UNITED STATES PATENT AND TRADEMARK OFFICE

APPLICATION NO.	FILING DATE	FIRST NAMED INVENTOR	ATTORNEY DOCKET NO.	CONFIRMATION NO.
10/736,245	12/15/2003	Tod A. Kinsley	200309606-1	6437
22879	7590	06/17/2005	EXAMINER	
HEWLETT PACKARD COMPANY P O BOX 272400, 3404 E. HARMONY ROAD INTELLECTUAL PROPERTY ADMINISTRATION FORT COLLINS, CO 80527-2400			NICHOLSON III, LESLIE AUGUST	
			ART UNIT	PAPER NUMBER
			3654

Office Action Summary	Application No.	Applicant(s)	
	10/736,245	KINSLEY ET AL.	
	Examiner	Art Unit	
	Leslie A. Nicholson III	3654

DETAILED ACTION

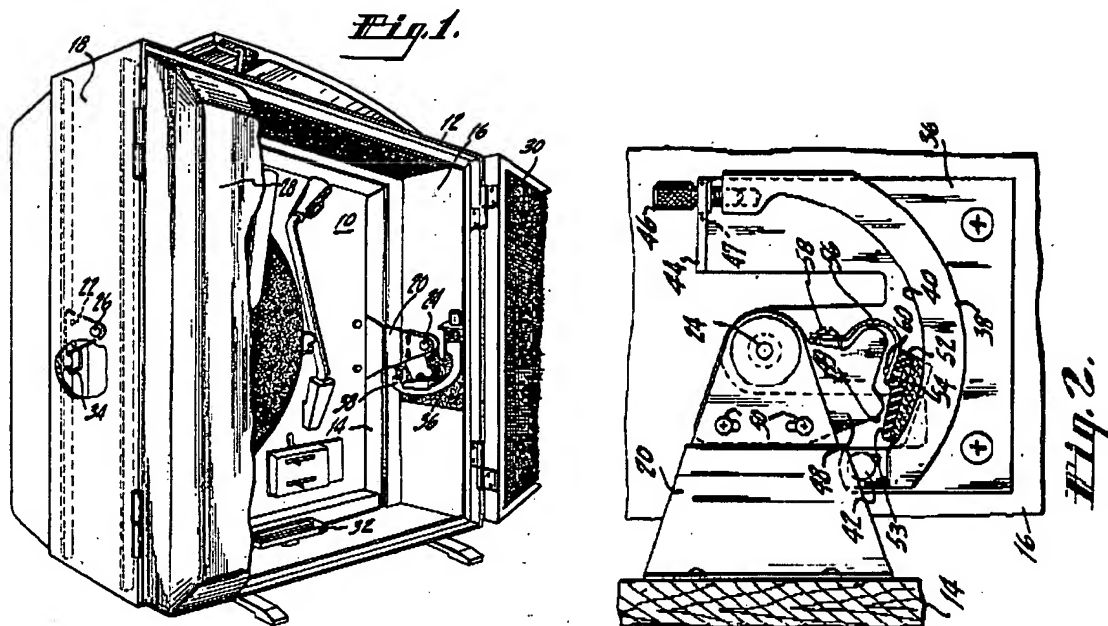
Claim 1,2,3,4,7,8, and 16 are rejected under 35 U.S.C. 102(b) as being anticipated by Gehrung (3,409,339). Gehrung discloses (column 1, line 23-36) a portable equipment cabinet carrying a sound reproducing apparatus (Fig.1 as shown below), which includes a pivotally mounted tray member, a brake member (reference number 52 in Fig.2 as shown below) provided for damping the pivotal movement of the tray when it is caused to move from a vertical position to a horizontal position to control motion. It is noted that "media" is defined as an object or device, such as a disk, on

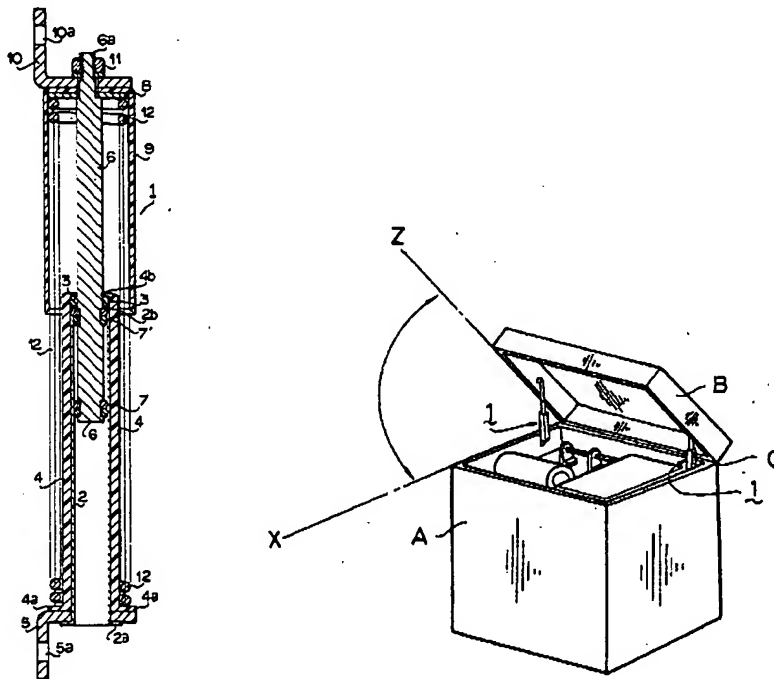
Claim 6 is rejected under 35 U.S.C. 103(a) as being unpatentable in view of Gehrung (3,409,339) and in further view of Ojima (4,457,497). Gehrung discloses a media handling device set forth in claims 1 and 3 with at least one second protrusion configured for removably mounting the damper on the frame, but does not expressly disclose a pair of second protrusions, nor does he disclose a pair of dampers mounted adjacent to each of the first protrusions. Ojima discloses a spring balancer (Fig. 1 as shown below), which comprises a damper, installed between a fixed body and a lid pivotally through a horizontal revolution axis. Ojima further discloses a pair of dampers (Fig. 2 as shown below), which are mounted on opposite sides of the frame via brackets

frame. Gehrung does not expressly disclose the securing portion on the inner end. The arm member including the shoe disclosed by Gehrung (reference 48,49, and 52 in Fig. 2 shown above) is shown as being generally, but not exactly perpendicular to the frame of the media device. It is noted that the term "generally" is defined as "not specifically" or "for the most part" and therefore "generally perpendicular" is not considered exactly perpendicular. It is also noted that the shoe and arm member assembly extend out to make contact with the track where the assembly is considered a finger. Gehrung, however, does not expressly disclose a finger at the inner end of the media tray. Therefore, at the time of invention, it would have been obvious to a person of ordinary skill in the art to make a media handling device wherein the media tray comprises a body and adapt a damping device, as set forth by Gehrung, with a finger extending generally perpendicular relative to the frame at the inner end of a media tray and adapting a bracket and pin for pivotally mounting at the inner end of a media tray in order for the first and second position of the tray to be about 90° from one another.

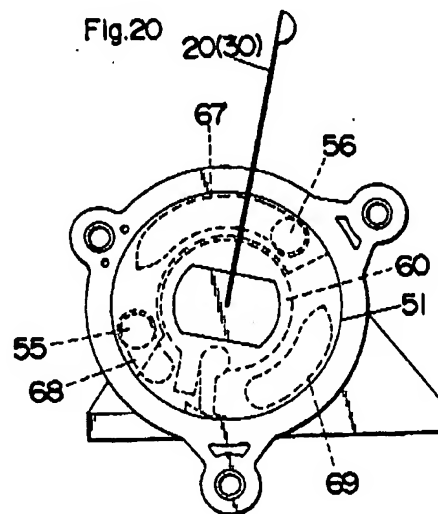
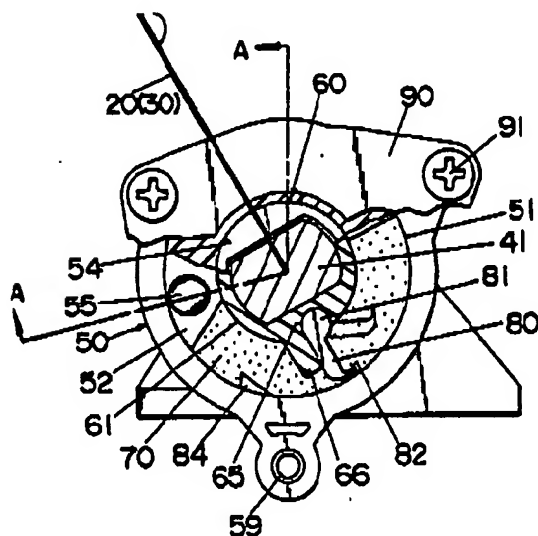
Gehrung discloses the media handling device set forth in claim 1 but does not expressly disclose a damper made of an elastomeric material nor a media tray made of a thermoplastic material. Joyce discloses a multiple compact disc supporting tray made of a thermoplastic material, but does not expressly disclose a media handling device comprising a media tray mountable to a frame for pivotal movement nor a damper for maintaining frictional engagement with the tray. Winberg discloses an elastomeric damper, but does not expressly disclose a media handling device. At the time of

invention, it would have been obvious to a person of ordinary skill in the art to adapt a media handling device with a frame, a media tray made of a thermoplastic material mountable to the frame for pivotal movement between a first and second position, and an elastomeric damper disposed on the frame and configured for frictional engagement with a tray to insure a desired frictional sliding engagement between a finger tip and a damper.
